ZONING COMMITTEE STAFF REPORT

FILES # 14-094970

- A. **PURPOSE:** Site plan review for a new student center for Metropolitan State University
- B. **PARCEL SIZE:** 40,000 square feet
- C. **EXISTING LAND USE:** Surface parking lot

LANDSCAPE PLAN
200.LP

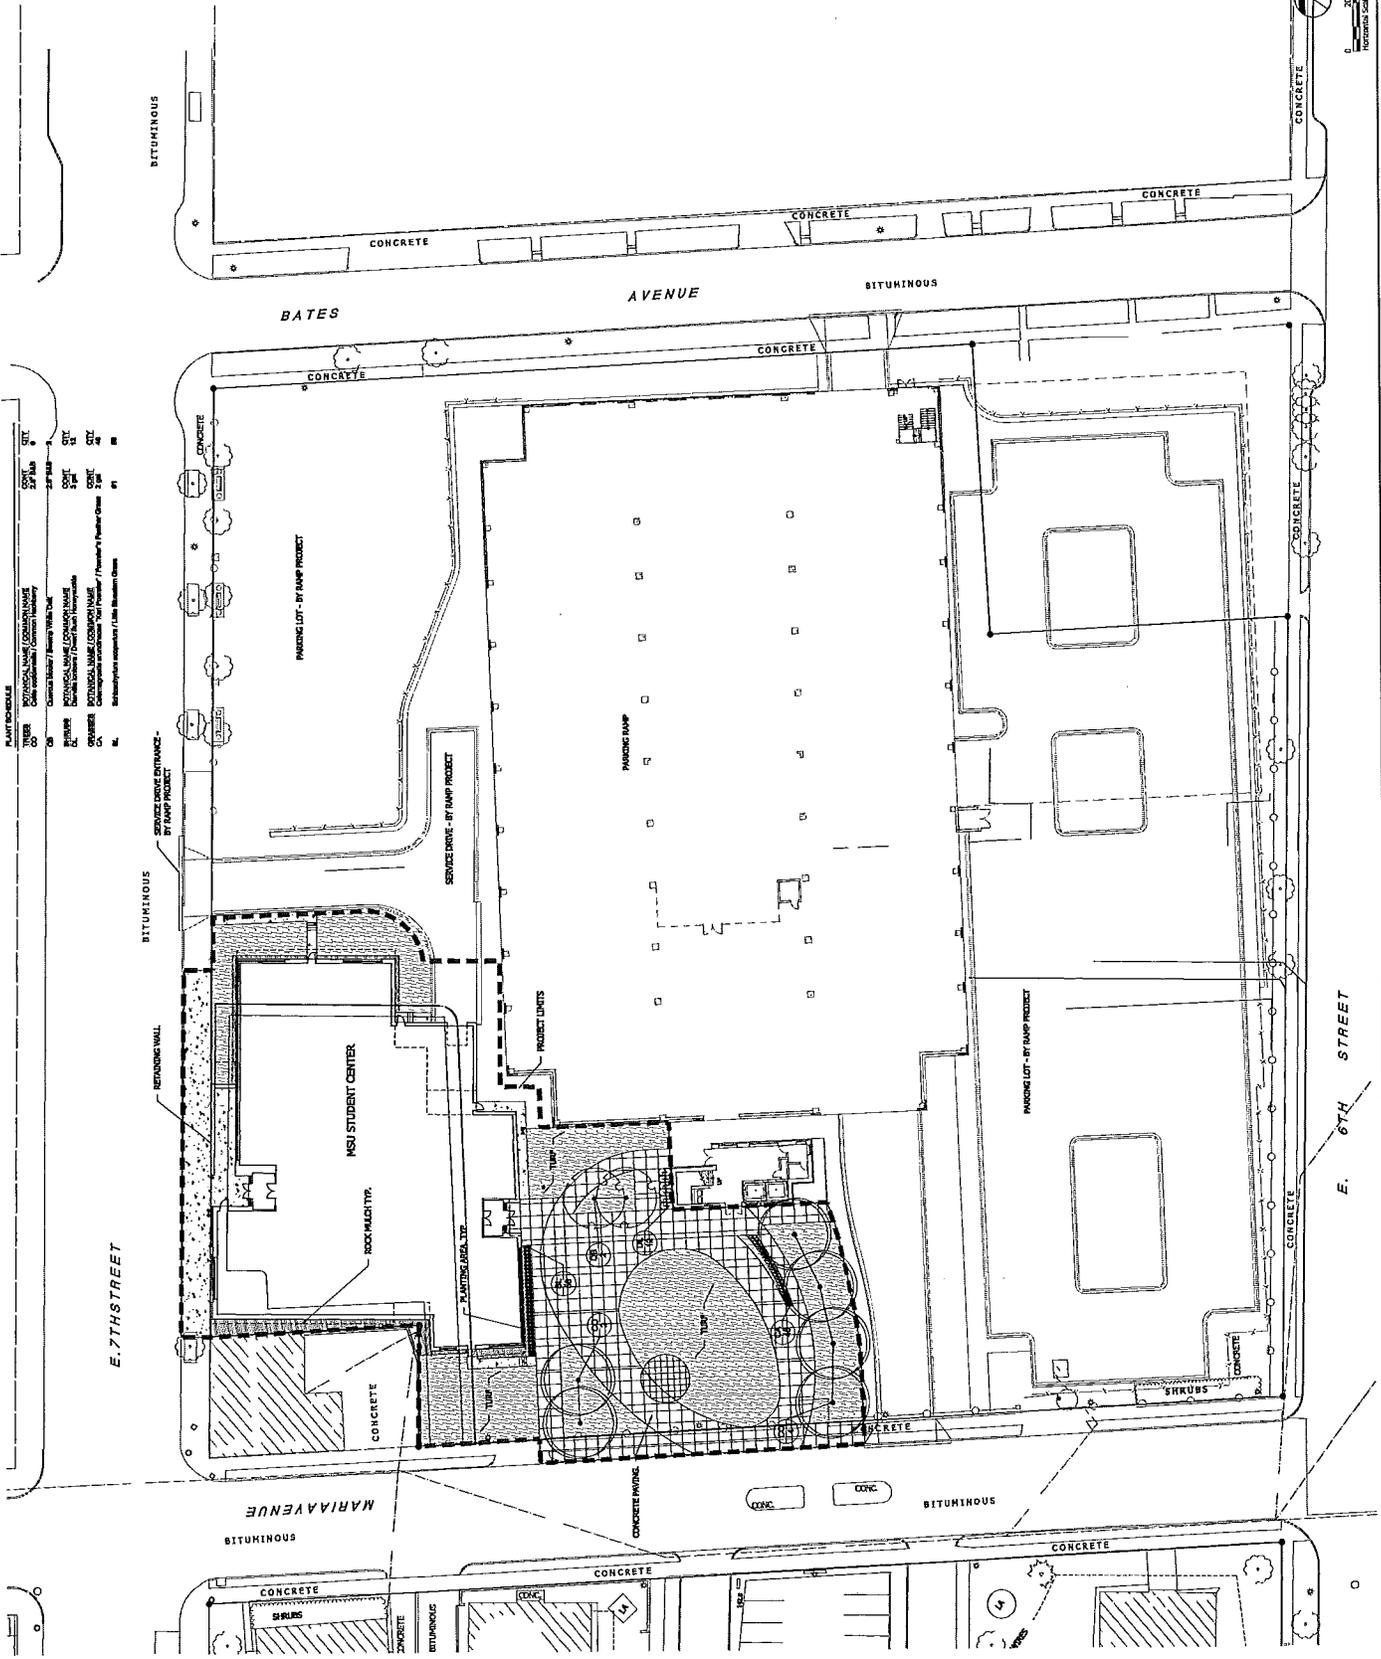
The site plan meets this finding. The south half of the site will be a new landscaped plaza for the campus. Parking is being provided by a new ramp which is going through a separate site plan review.
